PRELIMINARY

SP245

v1_Preliminary Plan Drawings.pdf Markup Summary

1 of B SHEET

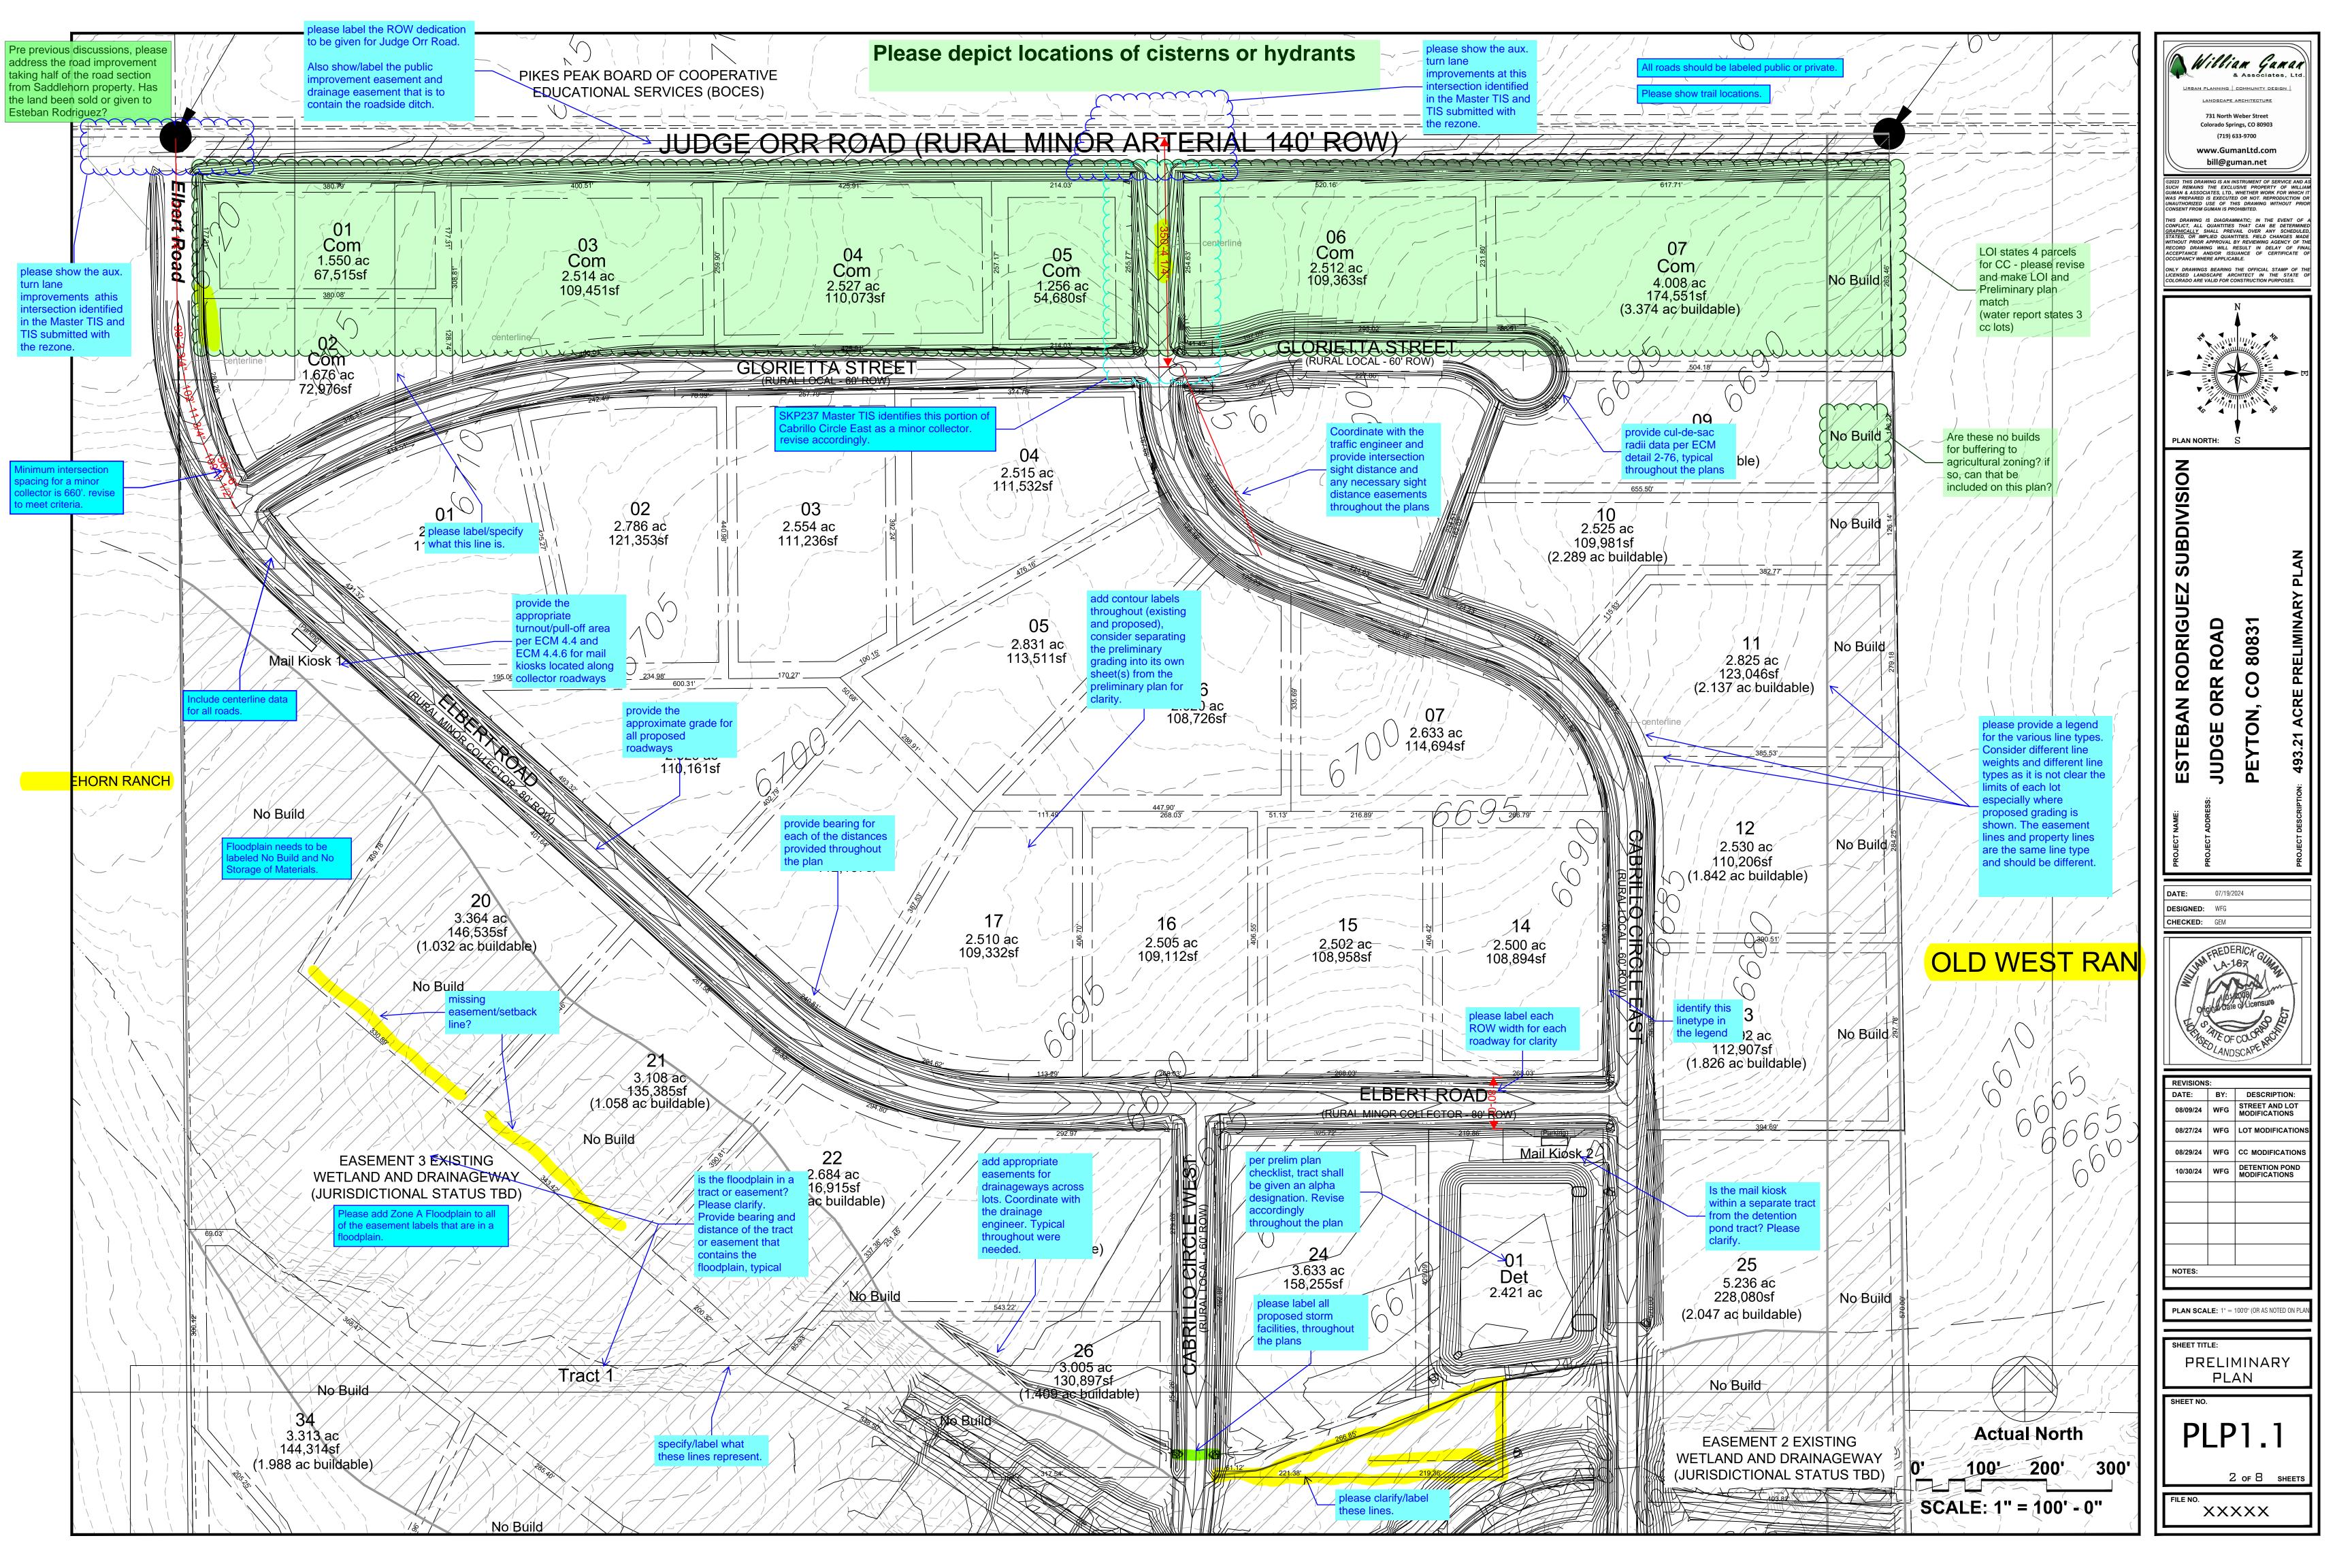
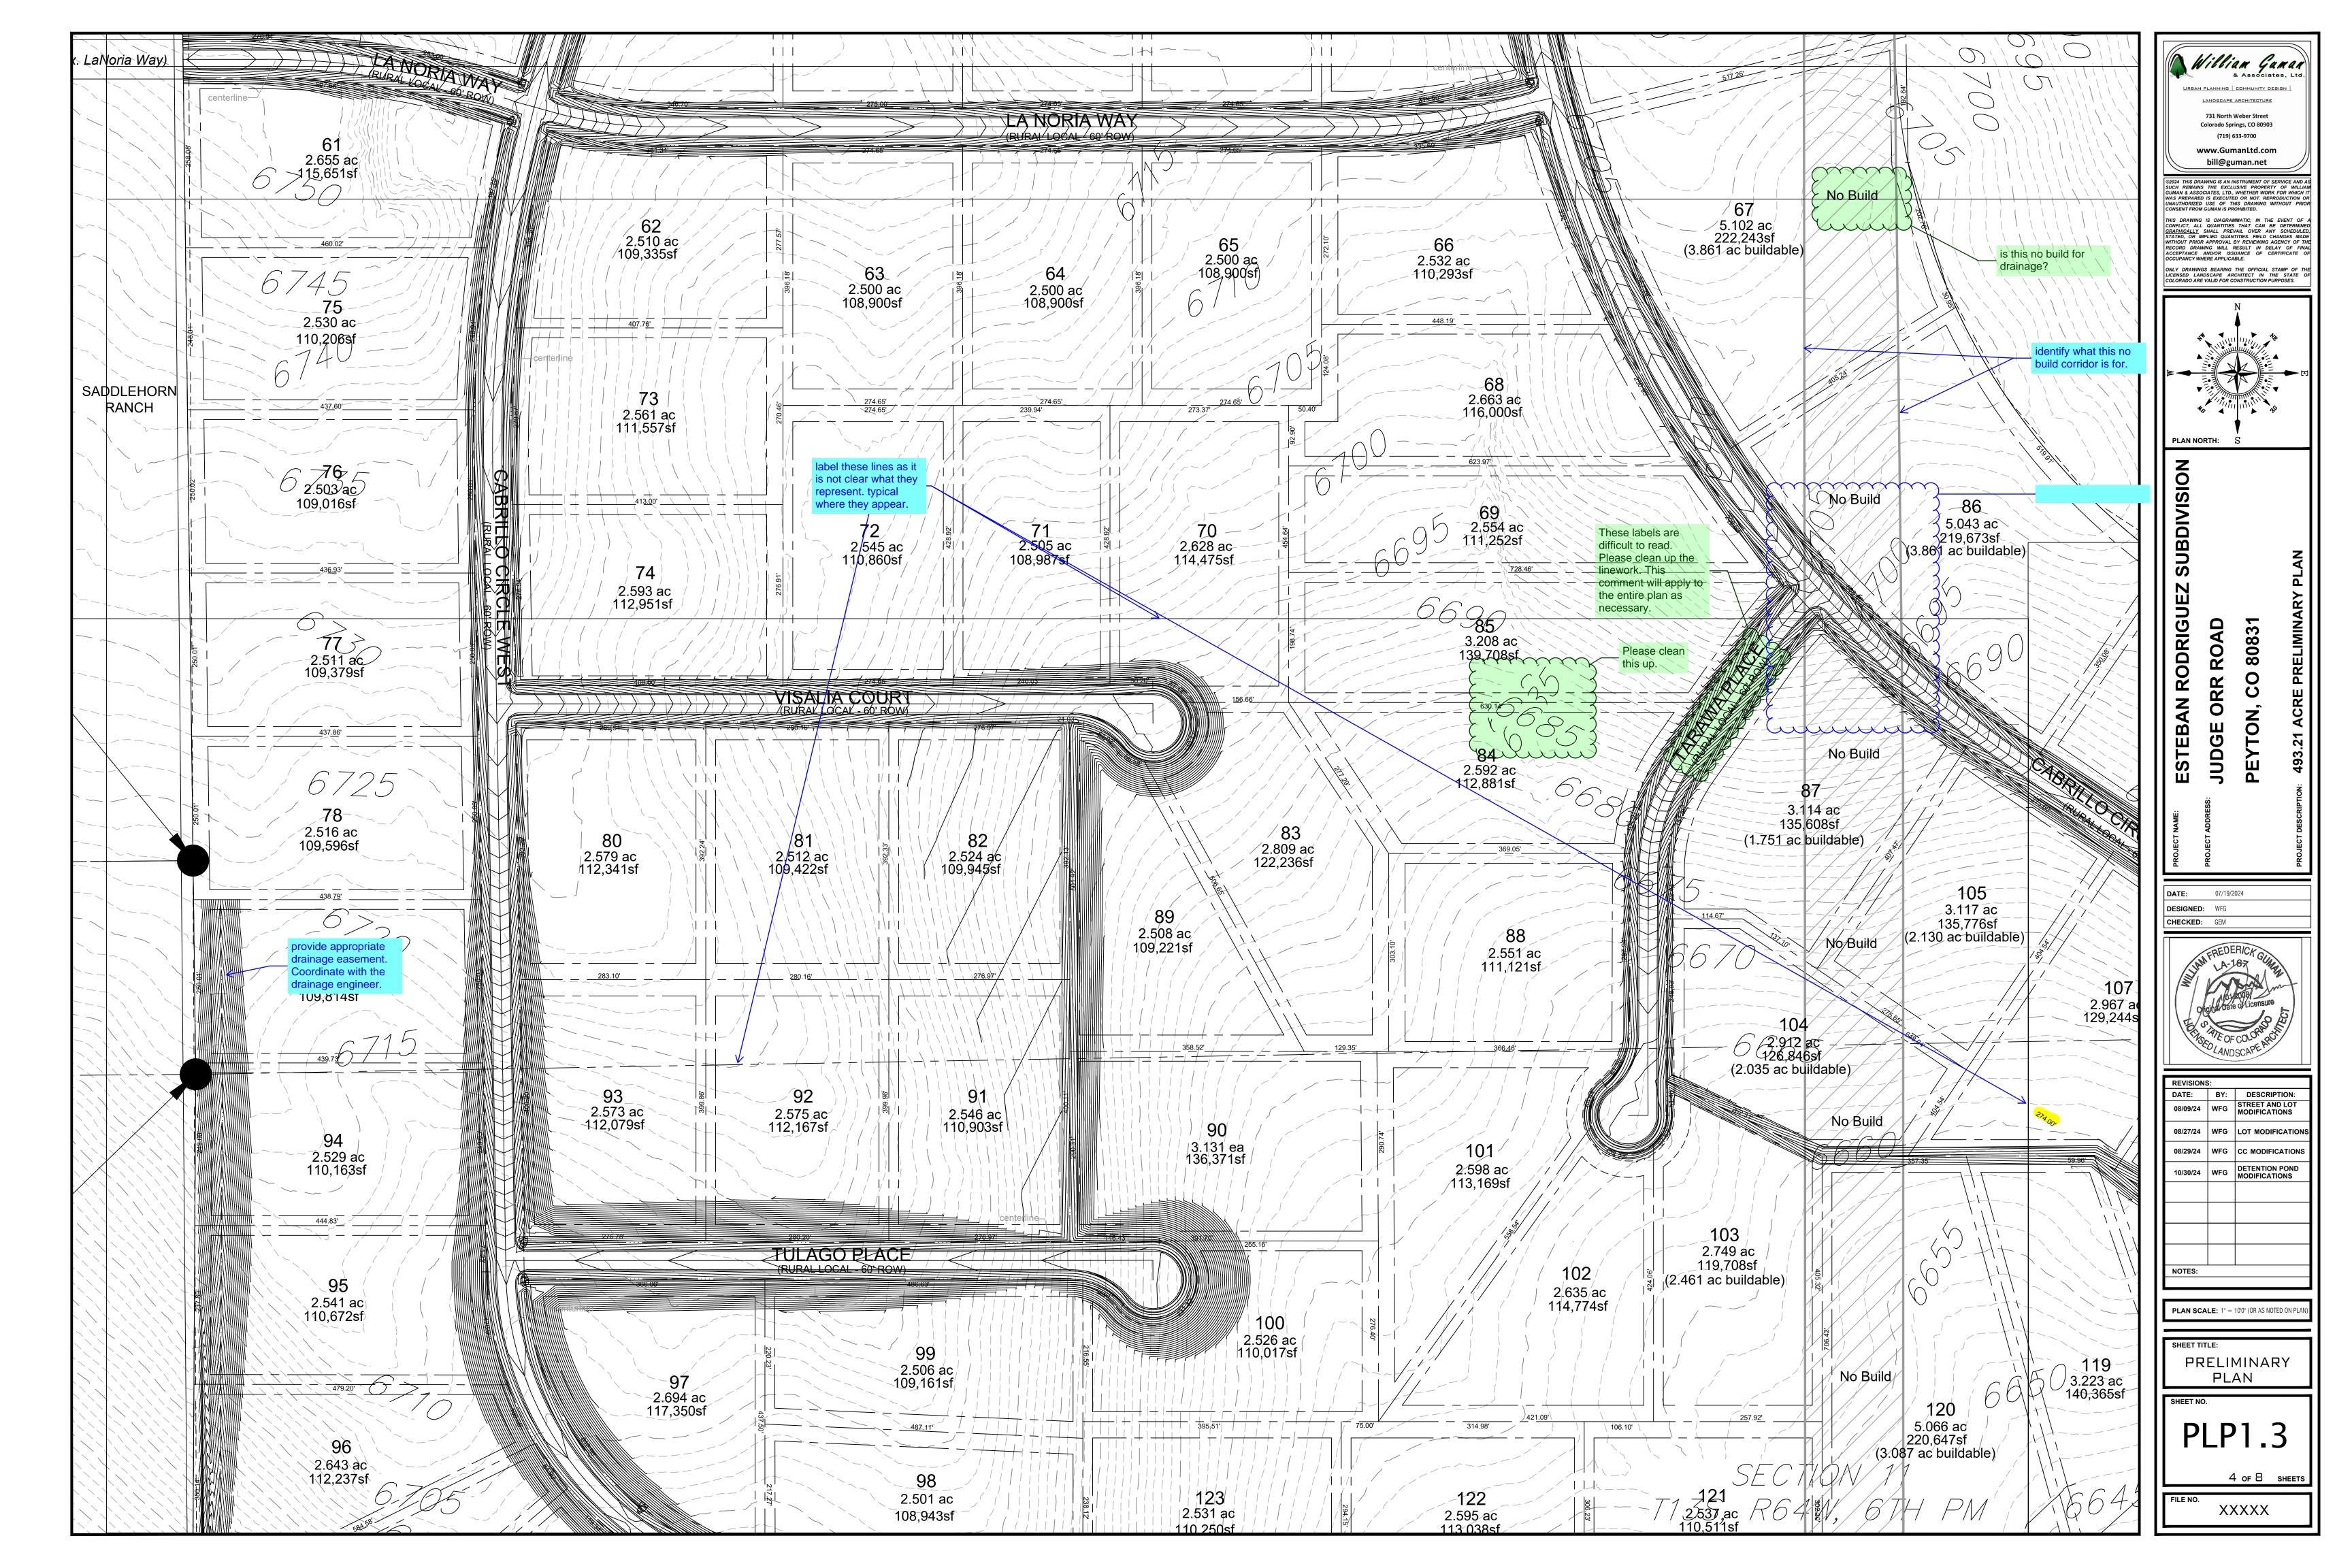
one note

recommend i

a condition of

expiration

Status: Color: ■ Layer: Space: Include standard soils and geo note as seen

Status: Color: E Layer: Space: make the language specific to the well and septic

Status: Color: Layer: Space: please update this to preliminary plan

Status: Color: ■ Layer: Space: make sure this is one note

Status: Color: Layer: Space: please make it more obvious where these areas are on the plan other than no build areas, the no build areas represent multiple items and it should be better specified

Status: Color: Layer: Space: lot number has increased from sketch plan - this

cannot be increased, change to 142

Status: Color: Layer: Space: recommend remove this note , this will be a condition of approval and it will be changed to 2 yr

Status: Color: ■ Layer: Space: recommend removal covered in note 25

show 2% per EPC standard detail.

Status: Color: Layer: Space: remove this sketch plan note

Status: Color: Layer: Space: Please remove or revise this note #5. The access points are not conceptual at the prelim plan stage.

Please show existing and future roadway cross sections separately for clarity.

Please add typical slopes to all sections.
